Project #23-005
Altitude
Located at approximately 2200 South 800 West

Project Name: Altitude
Proponent / Owner: Nathan Leishman / Altitude Property LLC
Project Address: ~ 2200 South 800 West
Request: Design Review & Subdivision Permit
Current Zoning: Mixed Residential Medium (MR-20)
Type of Action: Quasi-Judicial
Hearing Date: January 12, 2023
Submitted By: Russ Holley, Senior Planner

Figure 1 shows the proposed site plan

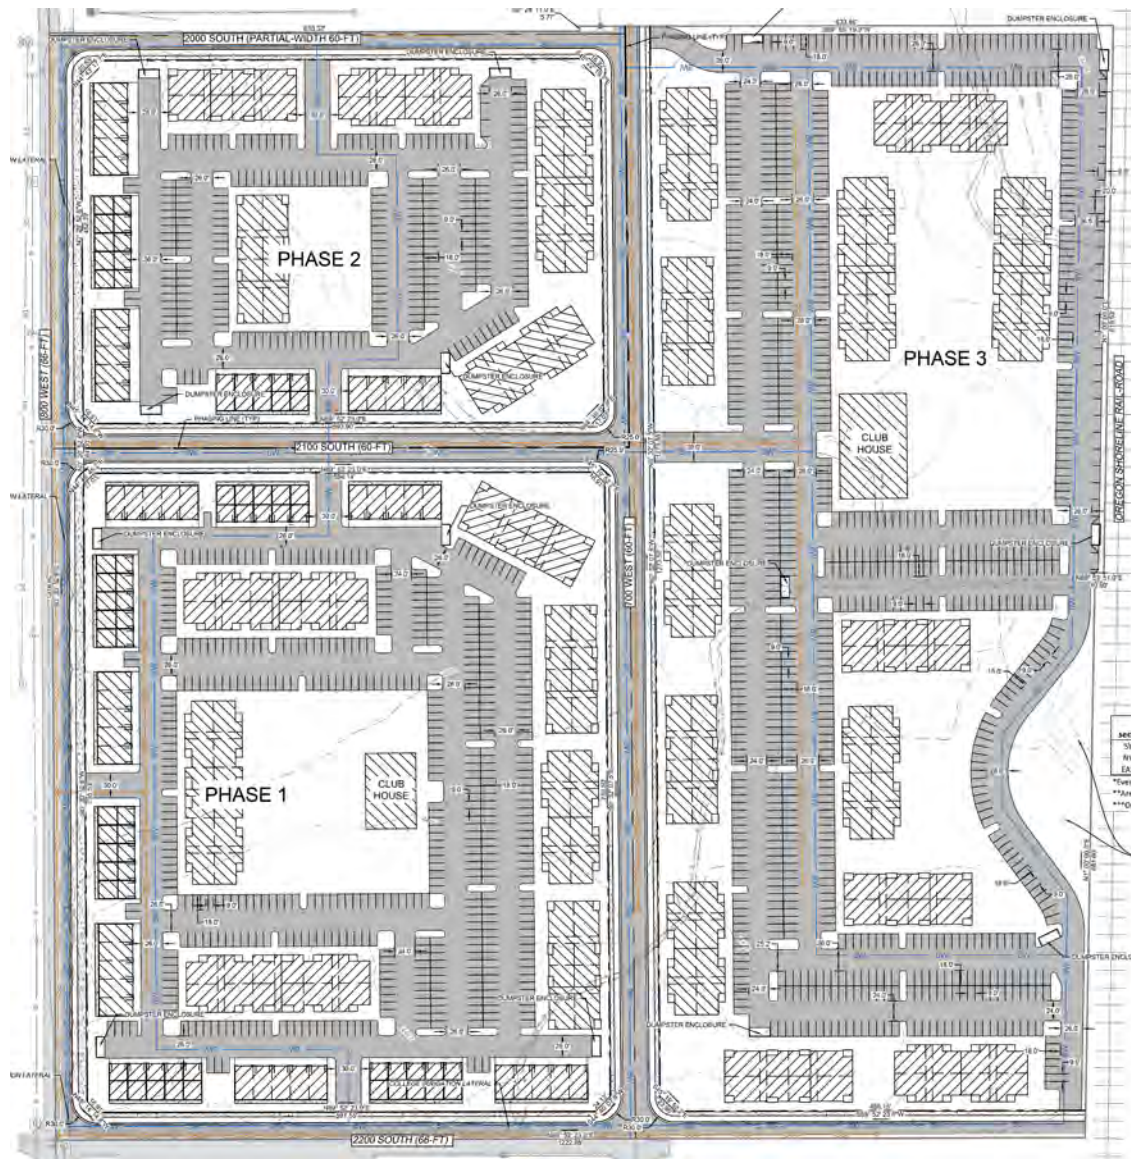
Multiple LDC code sections address street and block layout with the goal of creating well-connected neighborhoods and efficient transportation systems for all modes of travel. Logan City has a history of street layout that forms connected grid patterns and square shaped blocks. Areas of town, depending on topography, sensitive lands or other similar barriers have been permitted modifications at various times and under various previous version of city code. For approximately the last 20 years, Logan City codes have strengthened their requirements for creating well-connected street and block patterns. Limited modifications may be approved by the hearing body but must only be rooted in site-specific constraints listed in the LDC.

A joint statewide agreement between the Utah Department of Transportation (UDOT) and Union Pacific limits new intersections from being created within 250 feet of a railroad crossing. It is planned to create a new railroad crossing at 2200 South which is located at the southeast corner of this property. Considering the above code language and UDOT regulations, this property should be considered for modifications from the traditional block pattern because of railroad crossing regulations and the existing street pattern to the south (Nibley). The proposed road layout with the two typical blocks on the west side and one larger block on the east side are consistent with the intent of the City's grid requirements and within the purview of the Commission's discretionary authority. As conditioned, the project meets the requirements in the LDC.

The proposed project should be considered by the Planning Commission for a grid/street/block modification, façade variation levels, and walkability. With the railroad and limited crossing options, the proposed project shows connections to the areas to the north, west and south but not to the east. The code does allow for flexibility in dealing with pre-existing developments and/or existing physical constraints and this site may warrant deviations from exact 660' blocks. This property, at nearly 38 overall acres, should yield four blocks, but the Planning Commission will need to consider the railroad and consider the code language of "close match" for block deviation latitudes. The project meets minimum façade variation standards, but some building design have small "degrees" of variation. The Planning Commission may recommend different changes to achieve more noticeable variations within their legal powers. The other issues concerning open space, landscaping, sidewalks can be reasonably resolved through design detailing during the building permit and construction document process.

1. All standard conditions of approval will be recorded with the Design Review and are available in the Community Development Department.
2. The total maximum density of this project is 749 units. Each phase shall be proportionate in density so that if the project is abandoned between phases the remaining property can be developed without incumbrances. If the applicant submits a stamped and recorded property survey providing updated acreage, the maximum number of dwelling units may be adjusted provided the overall maximum density of the underlying zone is not exceeded.
3. The Planning Commission will determine the block connectivity and number of street connections.

SITE PLAN

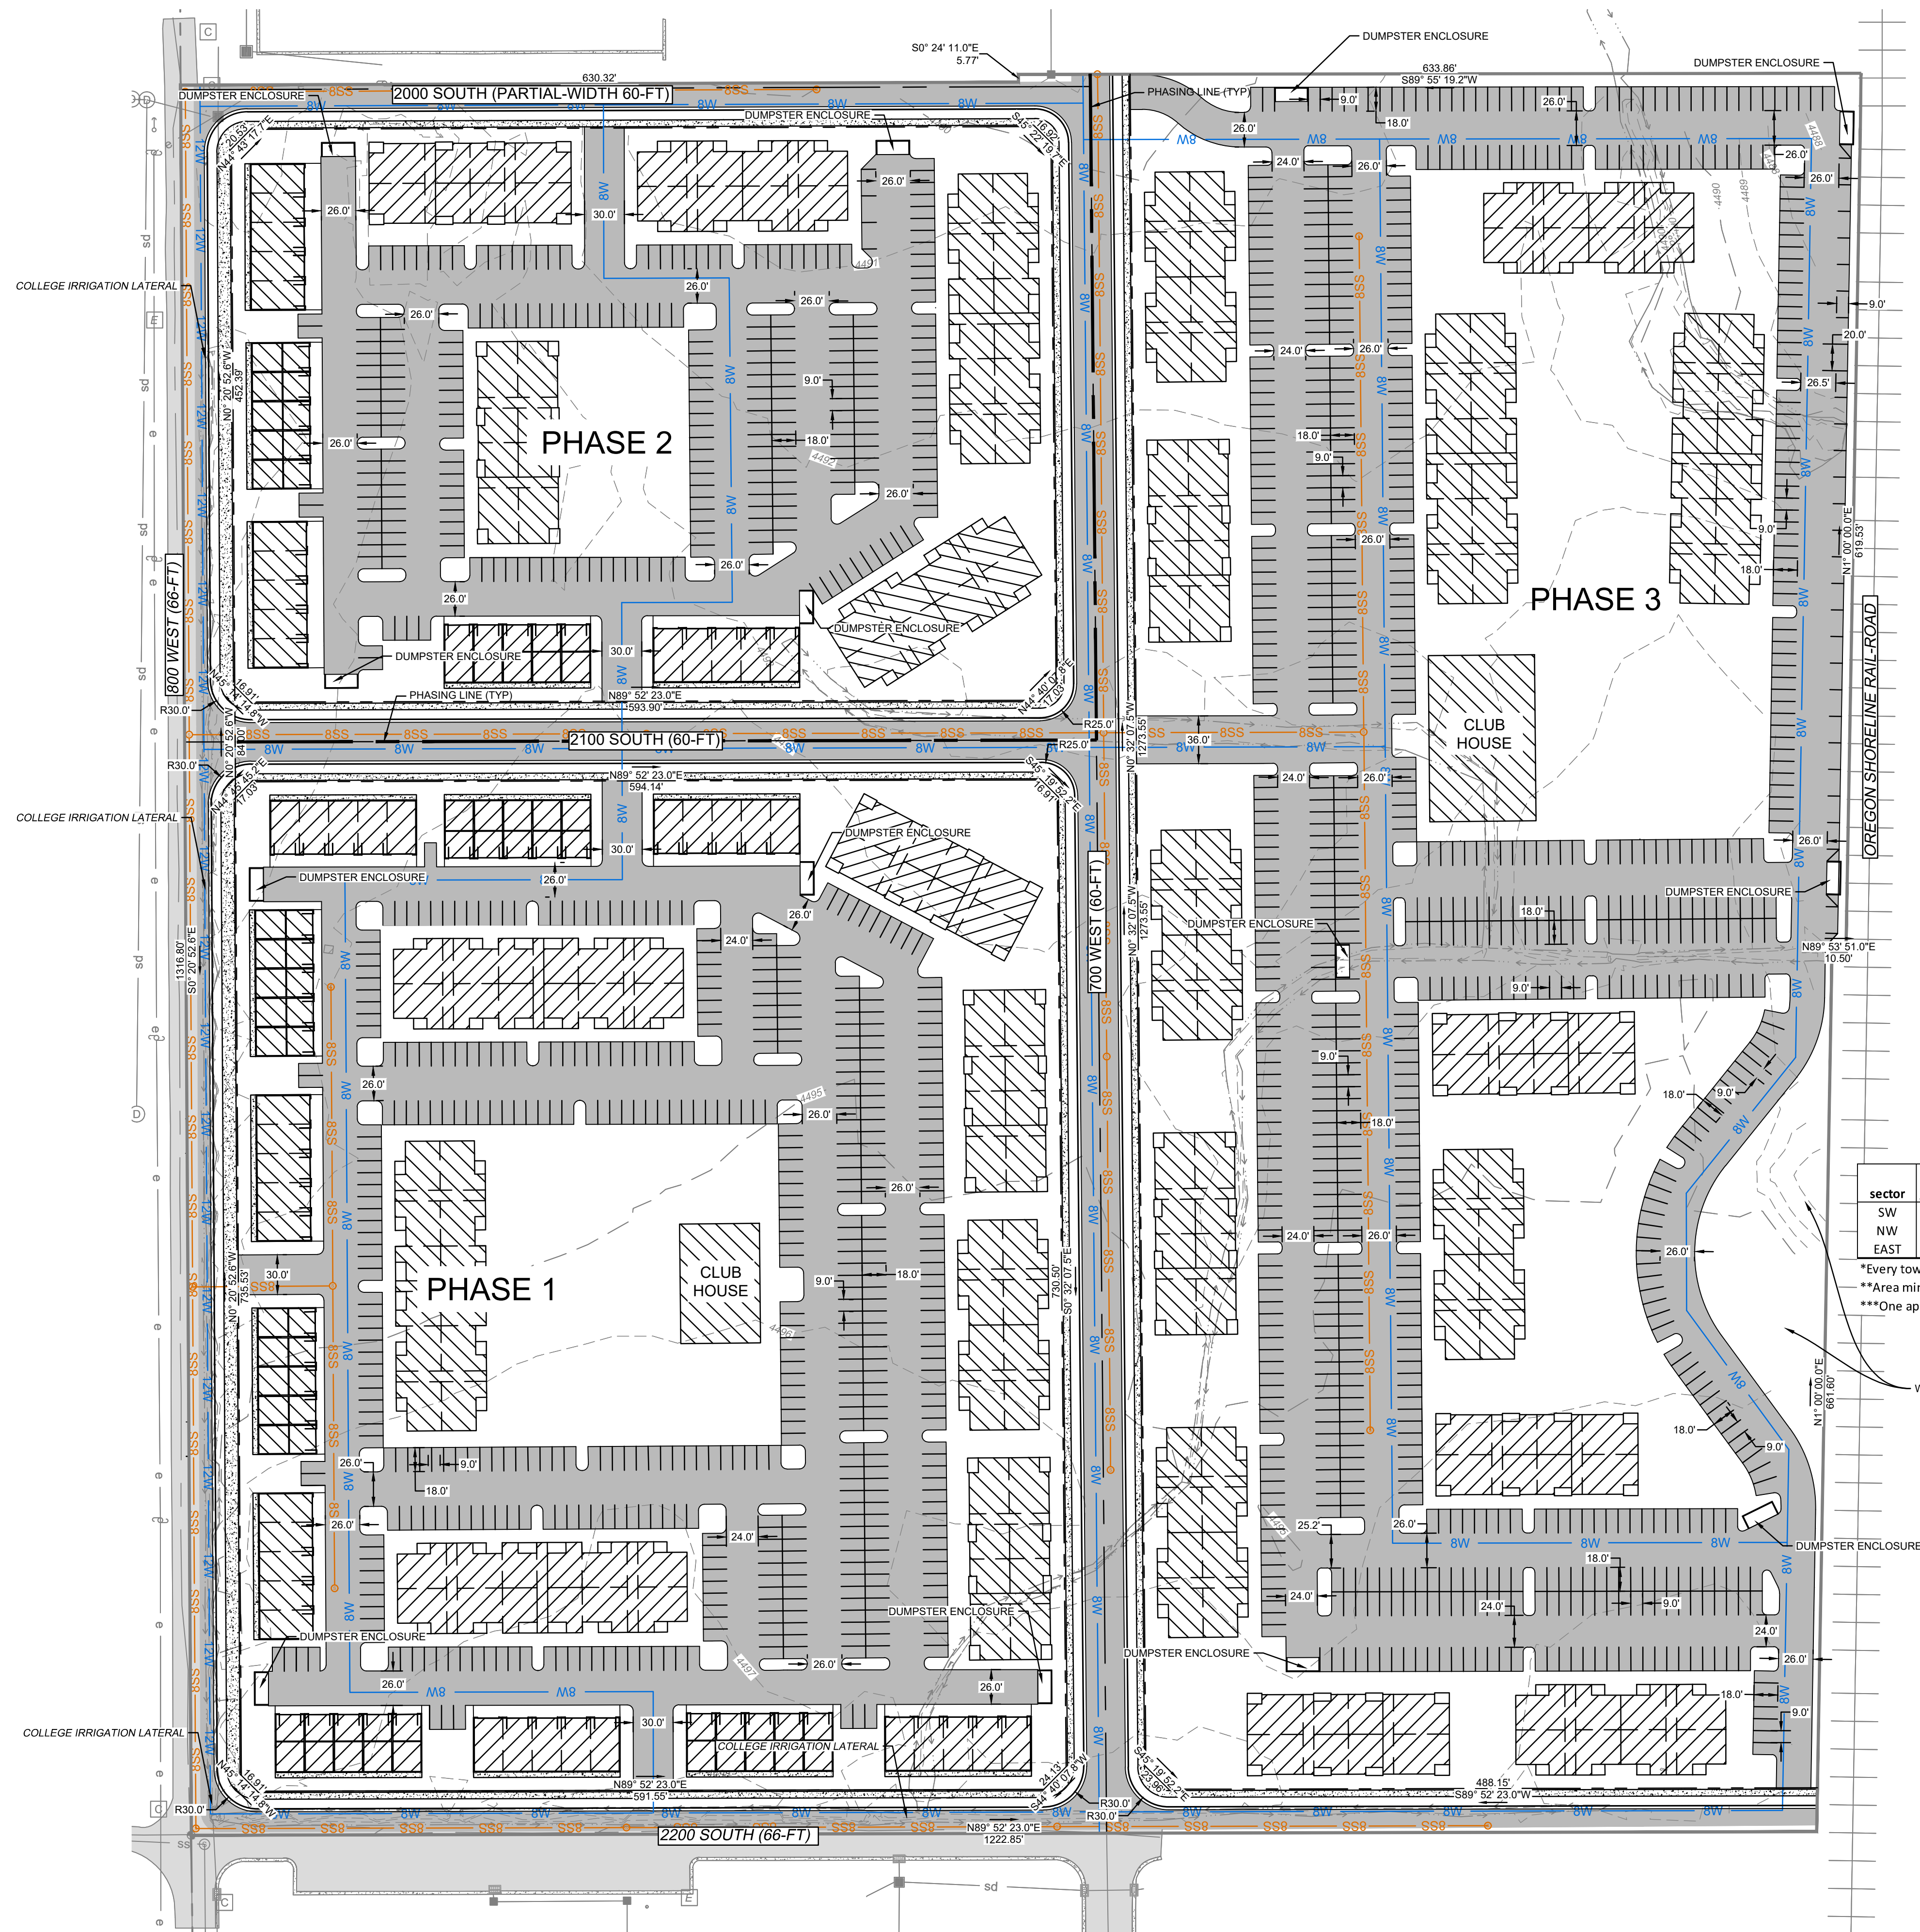
- 13) The nearest active City water line is currently located at the intersection of 2200 S and 1000 W and at 800 W (Hyclone Road) and US 89/91. The subdivision's water system shall be connected in two separate locations to the City's water system to provide a redundant supply for the number of residential units being served.

- 14) A new sewer main shall be constructed by the development to connect to the City's existing sewer system. There is insufficient capacity in the 2200 S sewer line west of 1000 West to serve the project. The nearest existing sewer line is located at 1000 W and 2075 S.

- 24) The plans submitted do not show storm water management improvements on the property, including the provision for storm water detention/retention basins. Additional common / open space area may be required to comply with the City's storm water management standards.

- 20) Provide storm water detention/retention per Logan City Design standards. This includes the retention of adjacent half street offsite where an existing management system is not established and onsite stormwater. Retention of the 90% storm event is required and shall be provided through the use of Low Impact design methods.
